Report of Dam Safety Assessment
of Coal Combustion Surface Impoundments
Interstate Power and Light Company
Sutherland Generating Station
Marshalltown, IA

AMEC Project No. 3-2106-0191

October 2012

DRAWING DESCRIPTION
CROSS SECTION LOCATIONS

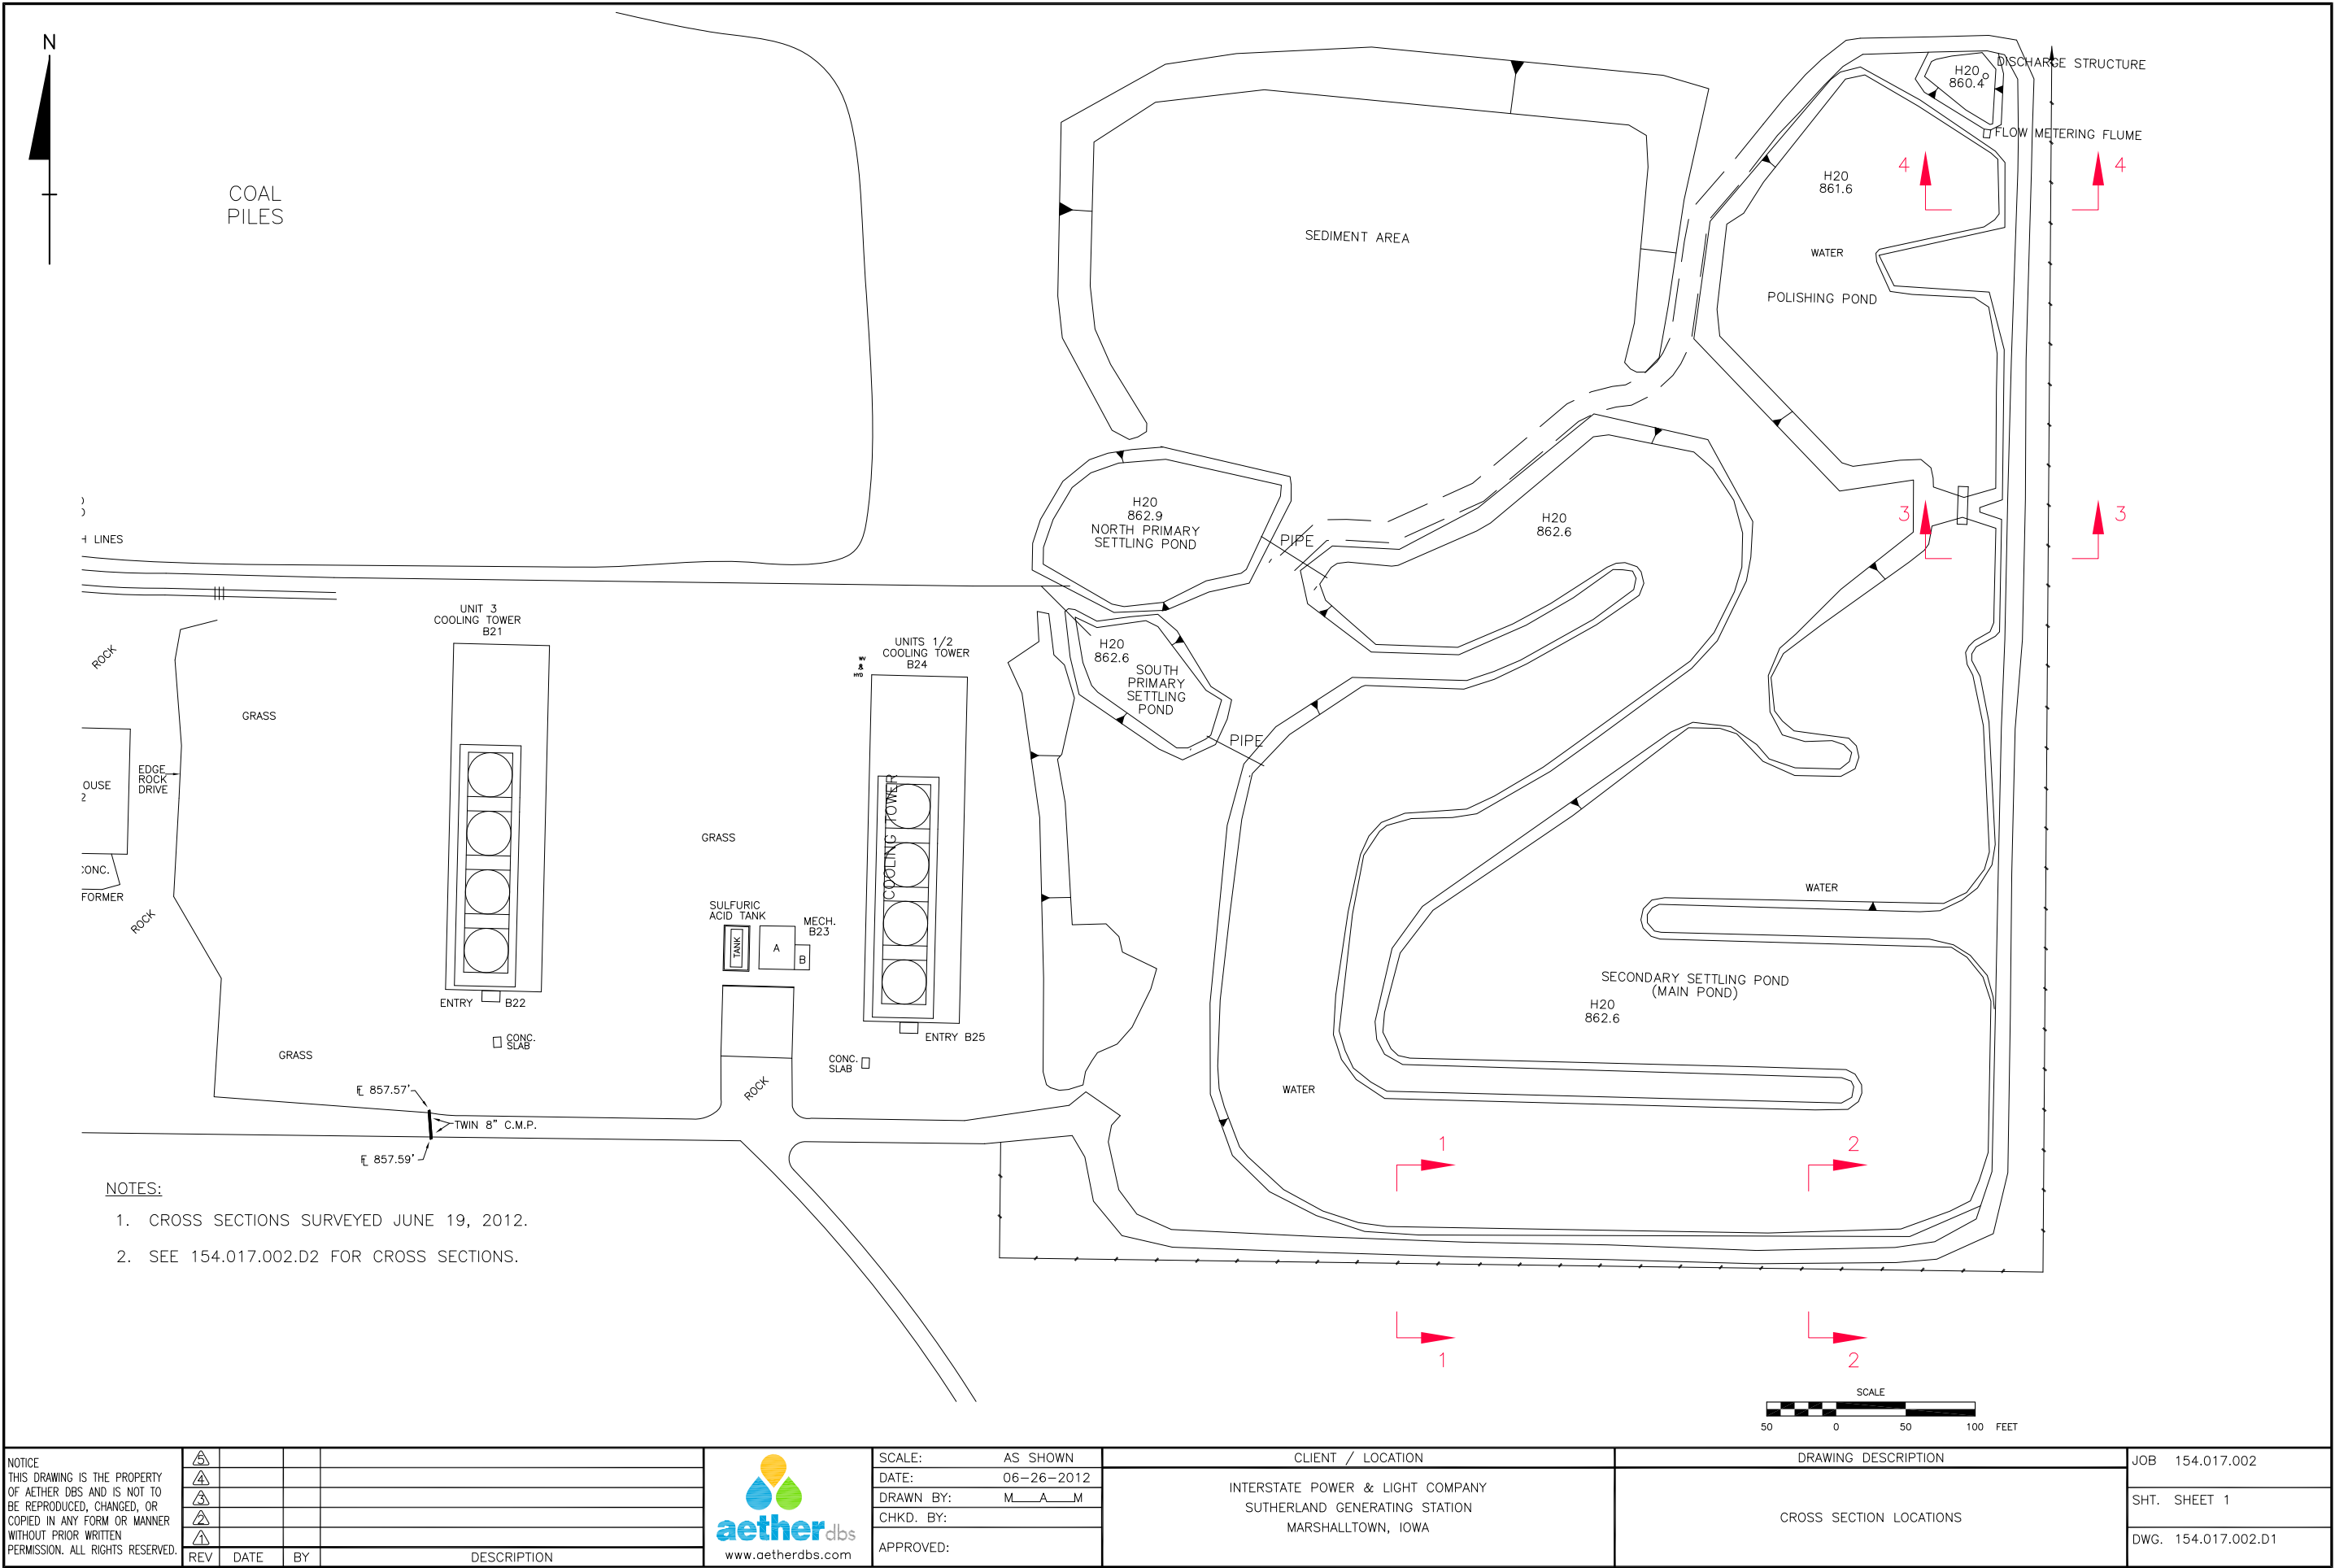
To resolve issues raised by AMEC on the geometric cross-section of the embankments, Aether surveyed the slopes at four locations in June 2012 as identified on Figure 1. The

sections correspond to the areas of concern expressed by AMEC and to the original critical cross-section selected by Aether. The survey results are shown on Figure 2 and the field measurements indicate that the downstream (outer) slopes of the embankment range from 2.25:1 to 1.6:1. The results also show that the toe of the embankment is at elevation 857 or 858 and that the embankments are up to 8 feet high. The upstream / inside slopes are much more uneven due to the 2006 ash removal in the main pond and/or wind/wave erosion in the polishing pond.

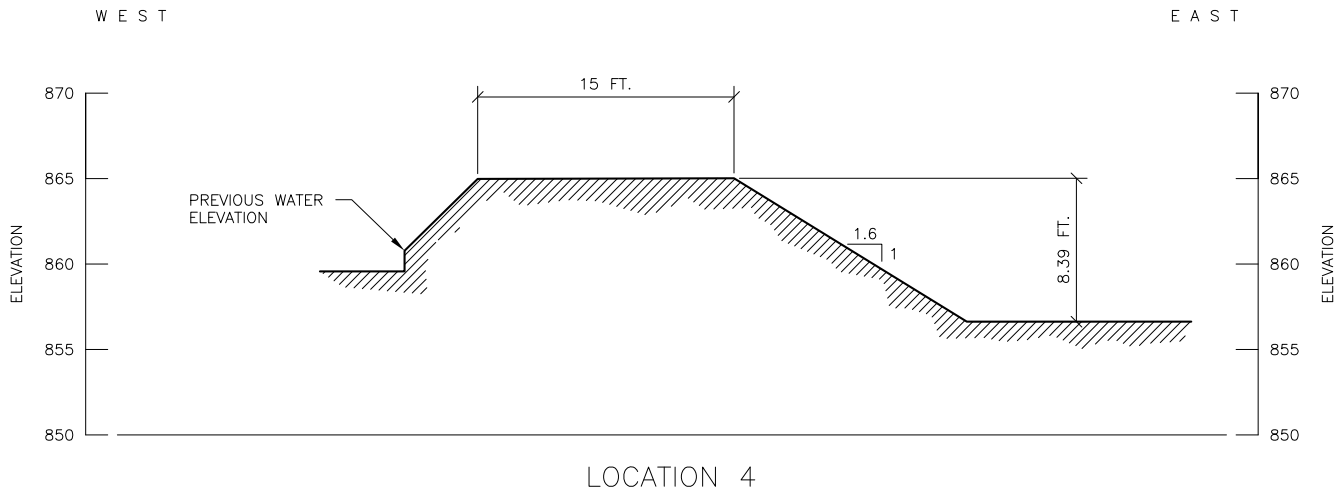
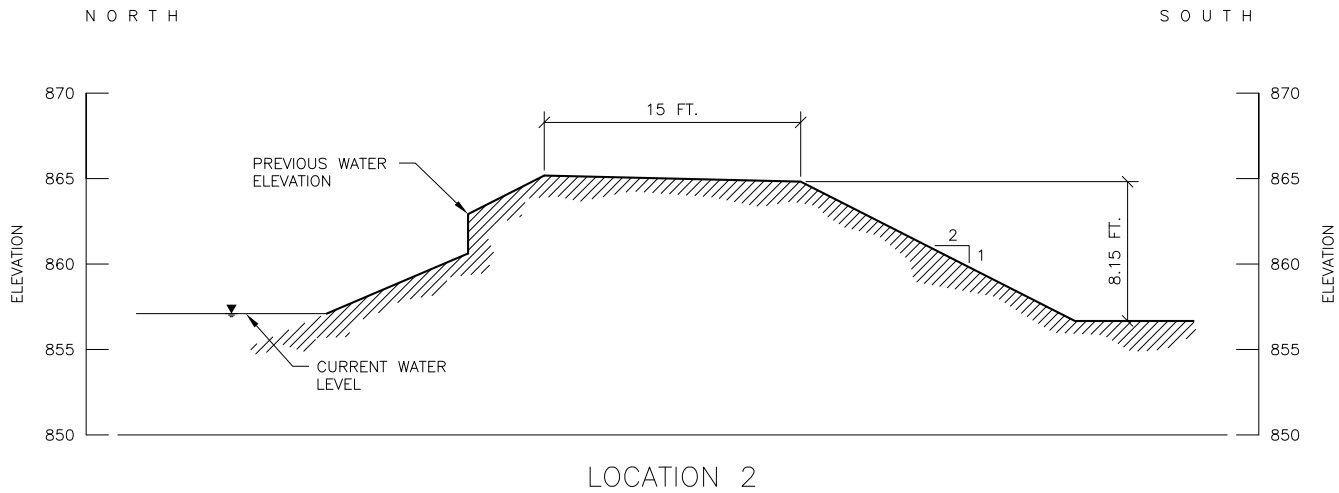
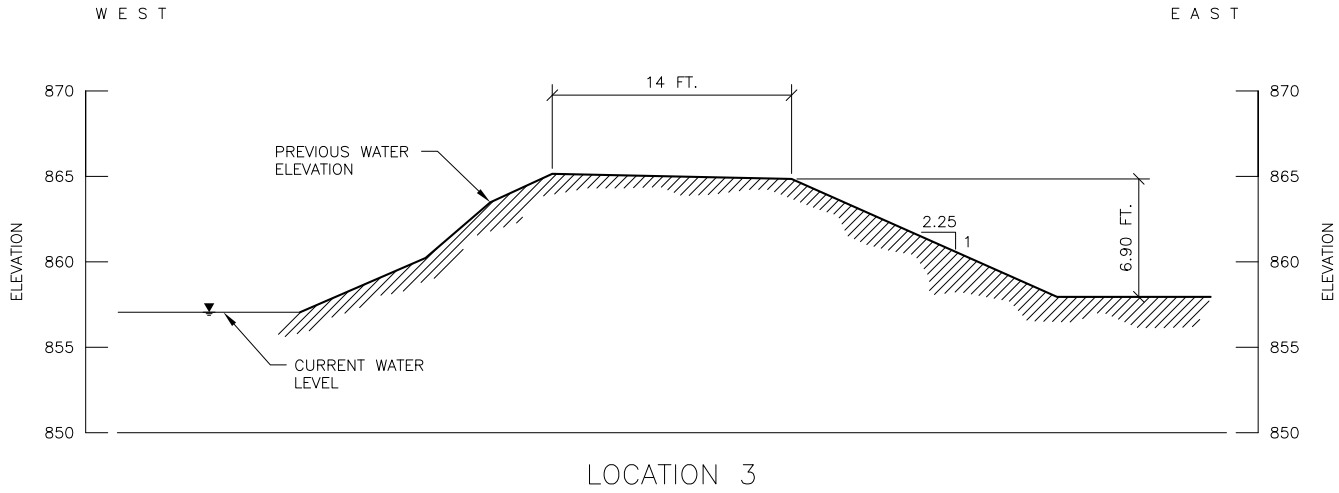
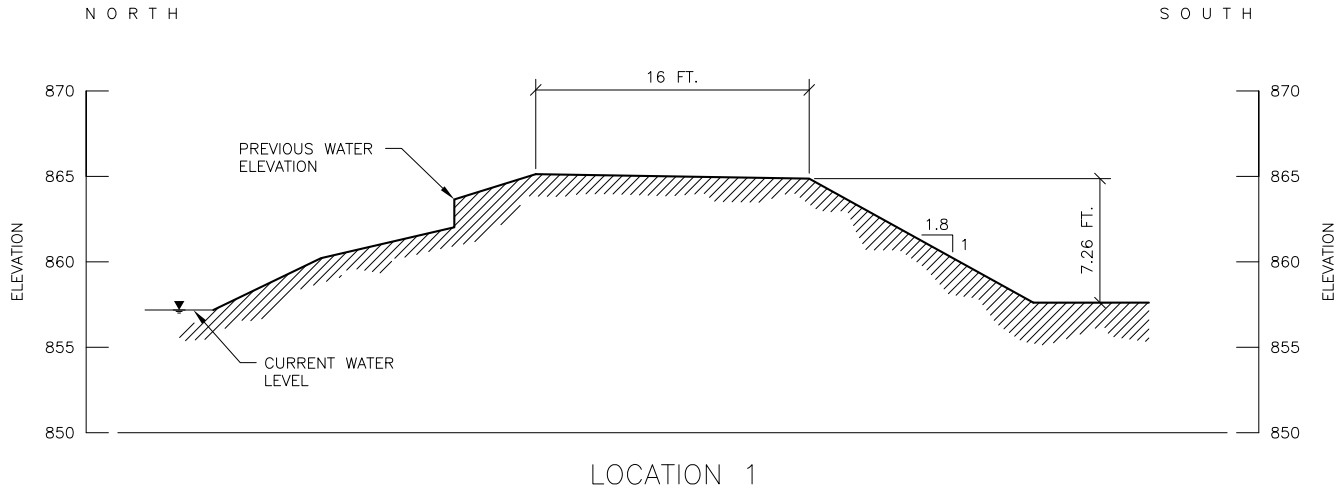
4. Critical Cross-Section Needs to be Measured – The results on Figure 2 show the measurements made at the two cross-sections noted by AMEC and two other locations selected by Aether. Due to the very short height of the embankments (eight feet versus thirteen feet), compared to the original analysis, the variations from 2 horizontal to 1 vertical on the outer slope are insignificant.
